Access Compliance Report Public Rights-of-Way (Curb Ramps)

Intersection ID: 13382 Main Street: E_CATHERINE_ST **Cross Street: S COLLEGE ST** Location:

ADA ID: 3254F2CB2A1B Ramp Type: PerpDiag Initial Pass/Fail: Fail **Overall Compliance: No** Severity Score: 26.25

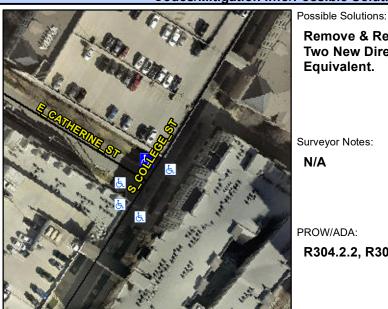
Cor	npliance Description	Data	Com	pliance Description	Data
N/A	Ramp Length (in)	104.0	No	Ramp Slope (%)	13.5
Yes	Ramp Width (in)	48.0	No	Ramp XSlope (%)	2.2
N/A	Flare Type LT	N/A	N/A	Flare Type RT	N/A
N/A	Flare Slope LT (%)	N/A	N/A	Flare Slope RT (%)	N/A
N/A	Flare Traversable LT?	N/A	N/A	Flare Traversable RT?	N/A
N/A	Landing Length (in)	N/A	N/A	DWS Provided?	N/A
N/A	Landing Width (in)	N/A	N/A	DWS Contrast?	N/A
N/A	Landing Slope (%)	N/A	N/A	DWS Length (in)	N/A
N/A	Landing X Slope (%)	N/A	N/A	DWS Full Width?	N/A
N/A	Landing Curb? (Y/N)	N/A	N/A	DWS Offset (in)	N/A
N/A	Shared Landing?	N/A			
N/A	Gutter Ponding?	N/A	N/A	Gutter Slope (%)	N/A
N/A	Gutter Lip Ht (in)	N/A	N/A	Gutter X Slope (%)	N/A
N/A	Painted X Walk1?	No	N/A	Painted X Walk2?	No
	X Walk 1 Direction	To SW		X Walk 2 Direction	To SE
N/A	X Walk 1 Width (in)	N/A	N/A	X Walk 2 Width (in)	N/A
	X Walk 1 Slope (%)	3.8		X Walk 2 Slope (%)	0.7
	X Walk 1 X Slope (%)	3.2		X Walk 2 X Slope (%)	1.3

Remove & Replace Curb Ramp With Two New Directional Ramps or Equivalent.

R304.2.2, R304.5.3
